Wiltshire Council Planning Consultation Response

Application No: **PL/2025/05762**
Full planning permission
Mixed-use commercial development including a convenience/food retail unit, a drive-through coffee unit, two B8 units with ancillary office use, and the retention of an existing B8 warehouse, along with associated parking, access, and servicing arrangements.
Armishaw Removals, Netherhampton Road, Netherhampton, Salisbury, SP2 8RA

Figure 1 – SFRA groundwater flood risk

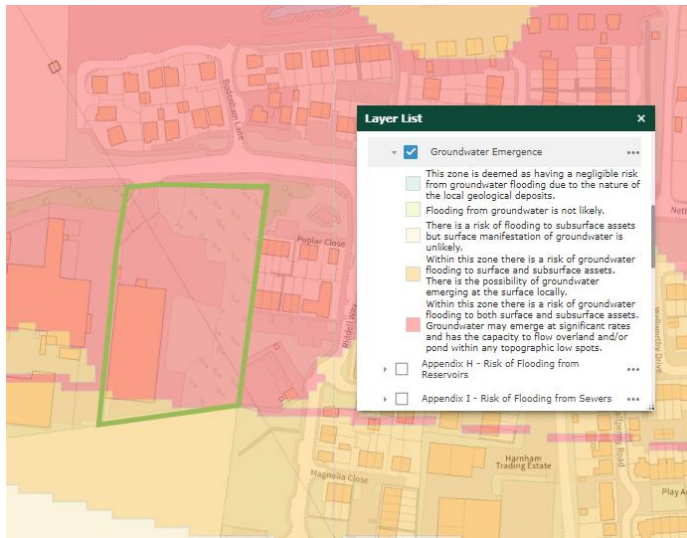
We note that the applicant has submitted an additional document, a Flood Risk Assessment (FRA). However, the FRA only addresses pluvial and fluvial flood risks. The Strategic Flood Risk Assessment (SFRA) mapping clearly indicates that the development site is also at high risk of groundwater flooding, which has not been adequately considered (see Figure 1)

- 1) **An updated site-specific Flood Risk Assessment (FRA) is required for this application. The site-specific FRA should demonstrate that the site is not adversely affected by flood risk from different sources, especially from groundwater, and how the flood risk from all sources will be managed without increasing flood risk to the development itself or elsewhere.**
- 2) **A drainage strategy is required to support this application. The surface water drainage strategy should include/demonstrate the following in accordance with the [National Standards for SuDS](#):**
